June 5, 2000
PY-CEI/NRR-2465L

Perry Nuclear Power Plant
Docket No. 50-440
License Amendment Request Regarding A Modification To The
Reactor Core Isolation Cooling System Initiation Logic

SUMMARY

FIGURE 2

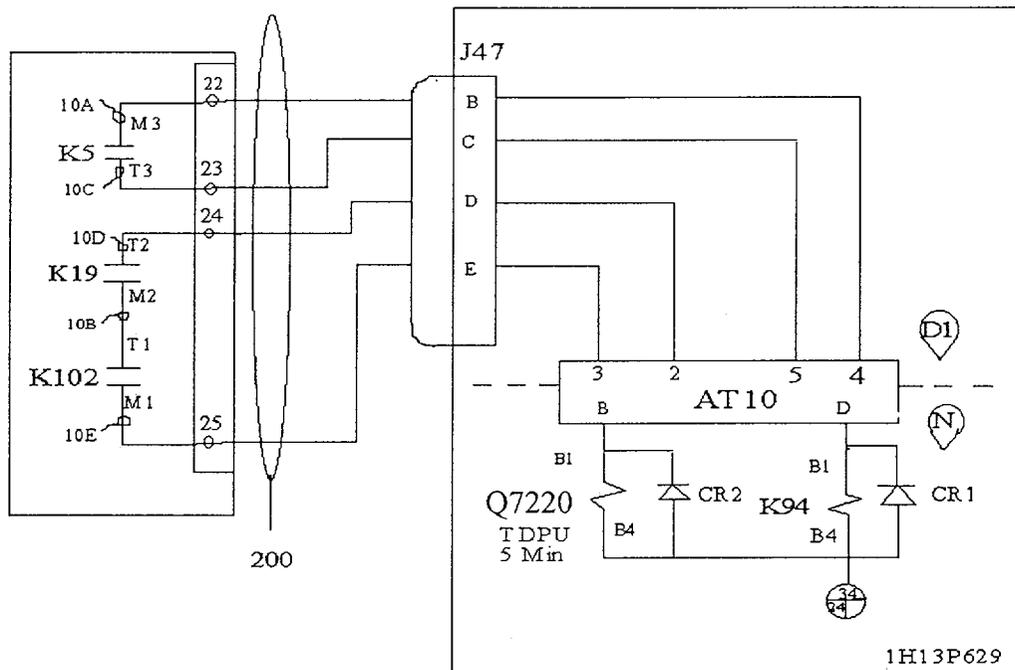
(After The Proposed Modification)

Explanation of logic: When RCIC is automatically initiated relays K5 and K102 are energized. Relay contacts K5 M3/T3 close. This energizes relay K94 through optical isolator AT10. Relay K94 contacts are wired to provide the RCIC initiation annunciator. When relay K102 energizes, relay contacts K102 M1/T1 will close. Note that relay K19 contacts M2/T2 will be closed when the RCIC system is in standby due to valve 1E51F0510 "RCIC Trip Throttle Valve" being open. Once relay K102 is energized relay 1E51Q7220 will start to timeout and will energize after 4-½ minutes. Relay 1E51Q7220 contacts are wired (when energized) to trip the Main and Feedwater Pump Turbines and to provide a turbine trip annunciator. Plant operators will shutdown the RCIC system once it is determined that the RCIC system is not needed (spurious initiation). The RCIC System Operating Instruction (SOI) directs the operator to close valve 1E51F0510 to trip the RCIC turbine. This will de-energize relay K19 and stop the 4-½ minute time delay relay 1E51Q7220 from energizing. An additional control switch (Not shown) will disable the 4-½ minute time delay feature by utilizing relay K94 contacts to trip the Main and Feedwater Pump Turbines when RCIC is initiated. The 4-½ minute time delay will be disabled when reactor power is less than 70%.
